**STEPHENS HILLSIDE FARM SUBDIVISION**  
34700 NE NORTH FORK AVENUE  
LA CENTER, WA 98629

**SHEET TITLE**  
PARK PLAN

**SHEET NUMBER**  
**L1.0**

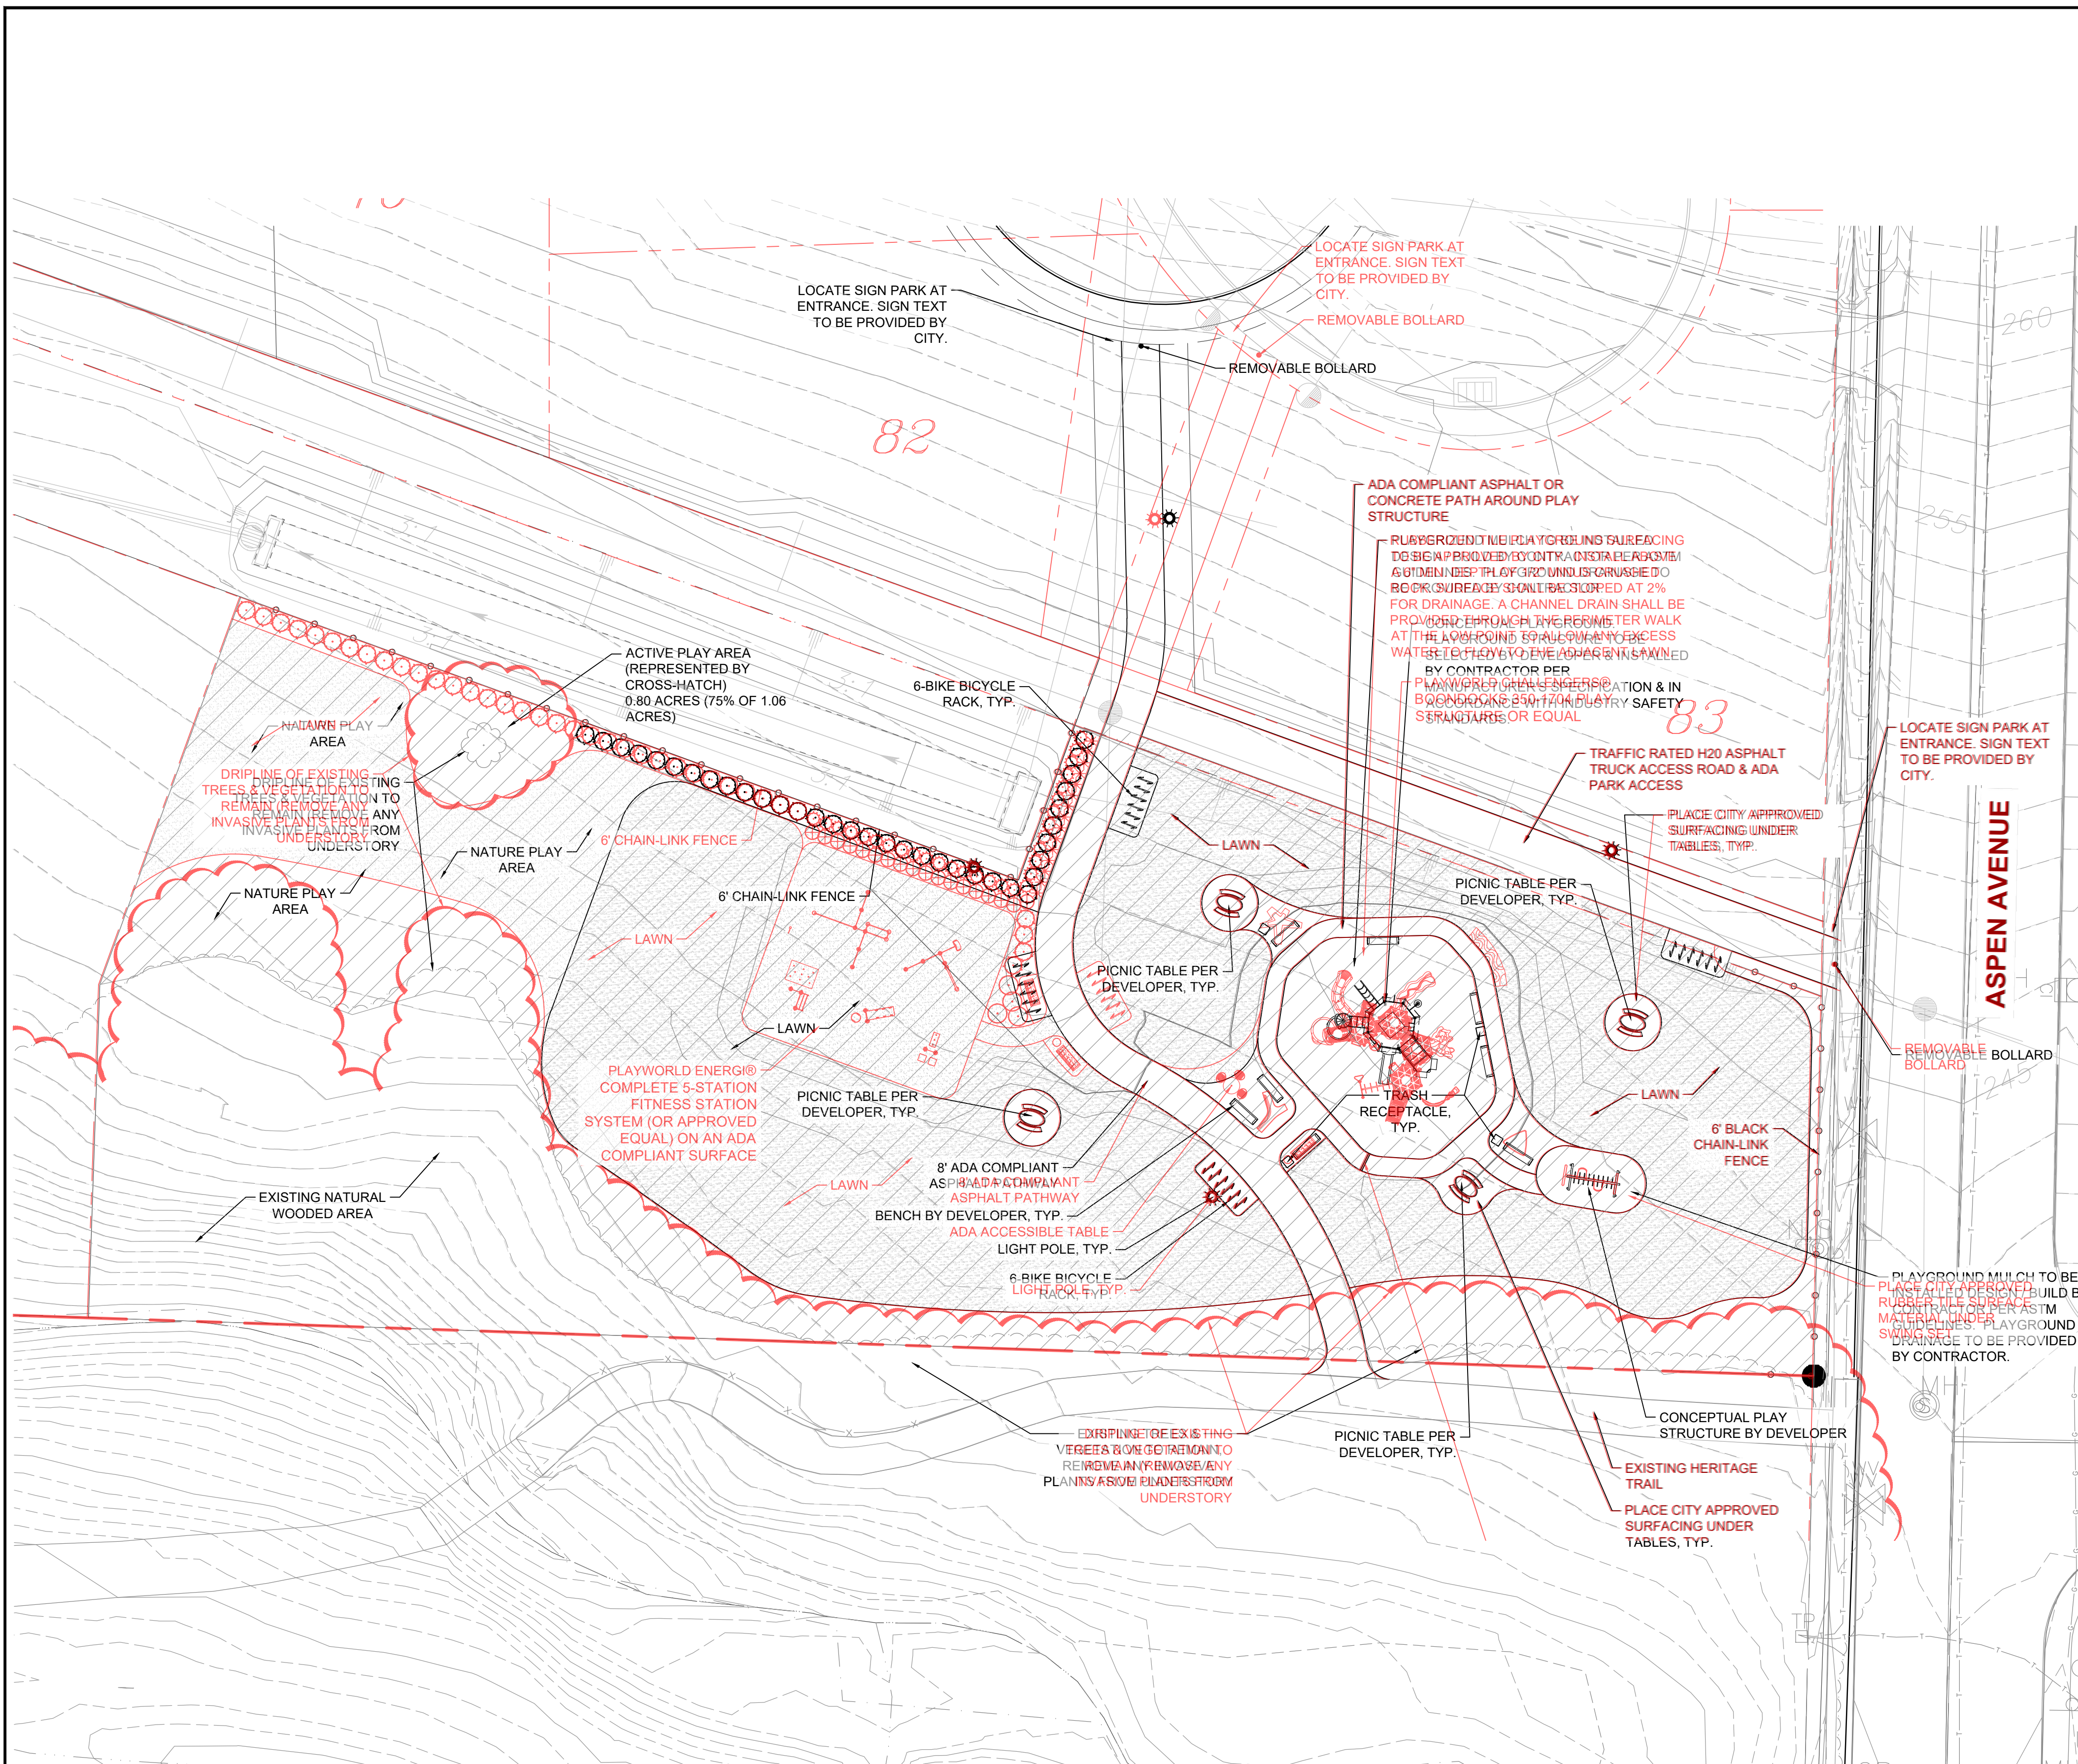
THE DIAGRAM ABOVE IS AN OVERLAY OF THE PARK PLAN FOR THE 2018 PROJECT AND THE 2022 REVISED LAYOUT, SUBMITTED FOR POST DECISION REVIEW. THE RED LINES INDICATE THE IMPROVEMENTS PROPOSED BY THE 2018 PROJECT. THE EXTENT OF THE PARK IMPROVEMENTS ARE REDUCED IN THE 2022 REVISED LAYOUT, SPECIFICALLY IN THE WEST OF THE PARK. AREAS IN THE EAST OF THE PARK WILL REMAIN EXISTING FIELD RATHER THAN IMPROVED WITH LAWN. THE WALKWAY, PICNIC TABLES, BIKE PARKING AND PLAYSTRUCTURE AREA IN THE EAST SECTION ARE UNCHANGED. IMPACTS ARE REDUCED BY THE 2022 LAYOUT. THERE ARE NO ADDITIONAL IMPACTS PROPOSED BY THE 2022 REVISED LAYOUT.
